Development Application **ACCESS REPORT**

Reference Number: 25046

Site Address: 82 Regent Street, Moama NSW.

Executive Summary and Design Compliance Statement

[Image description: Plan of at grade parking areas above shows the provision of Accessible parking spaces]

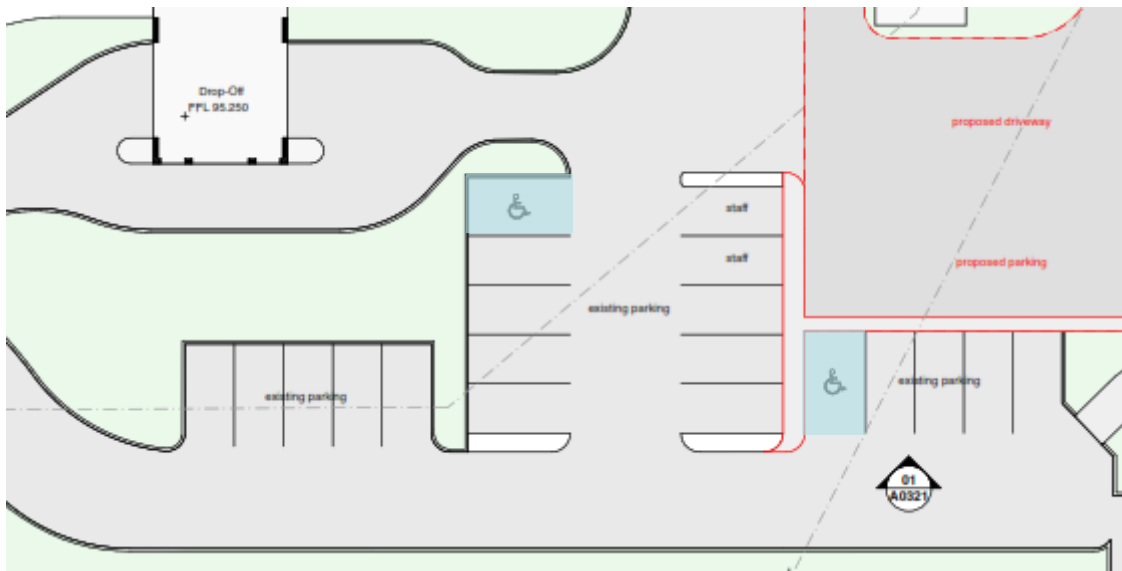
Total number of accessible parking spaces required as per the formula listed above in the requirements
= 2

Total number of accessible parking spaces provided as per the formula listed above in the requirements
= 2

If any car parking spaces are allocated specifically to the Class 5 or Class 9b components of work then additional accessible parking spaces will be required
This is to be assessed at CC stage of works.
